Thermawing Kit Modifications Amendment 1

This service bulletin (SB-06-002 Amendment 1) is being issued to upgrade the current Thermawing installations to the latest revision level. All effected parts should be replaced with the latest revision level parts included with this service bulletin. The parts installed prior to this service bulletin being issued will not affect the aircrafts safety or performance. The revisions are being issued strictly to increase the systems reliability.

Figure 1

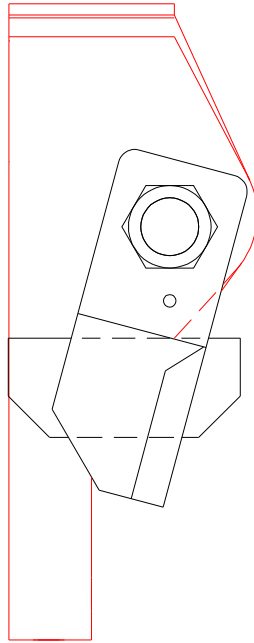
Along with the service bulletin, Kelly Aerospace has provided a hole transfer punch, roll pin, and a belt cutter (AL-00025). Push the belt cutter against the bracket and place the hole punch through the hole drilled on the belt cutter as seen in figure 1.

NOTE-Position belt
cutter as shown.
Refer to drawing on
page 3.

Figure 4

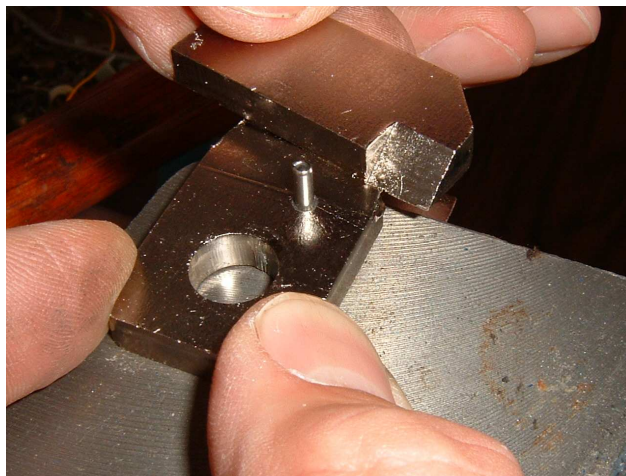
Take the belt cutter and place it on a hard surface. Place the roll pin on the hole in the belt cutter. Tap the roll pin into the hole so that it is flush with the other side of the belt cutter (See figure 4).

Figure 5

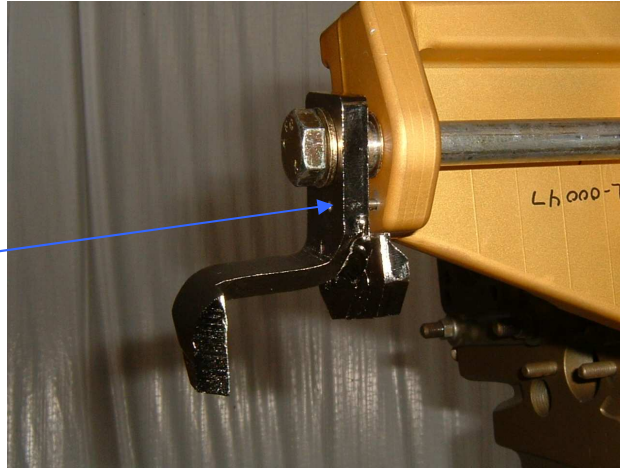
Place the roll pin attached to the belt cutter into the alternator bracket (see figure 5).

Notice the roll pin is flush with the surface of the belt cutter

Ensure that there is no washer between belt cutter and alternator bracket. Torque the nut AL-00030-S to 270-300 in-lbs dry. For the rest of the installation visit www.airplanedeice.com and download the latest revision to the Thermawing Installation Manual.
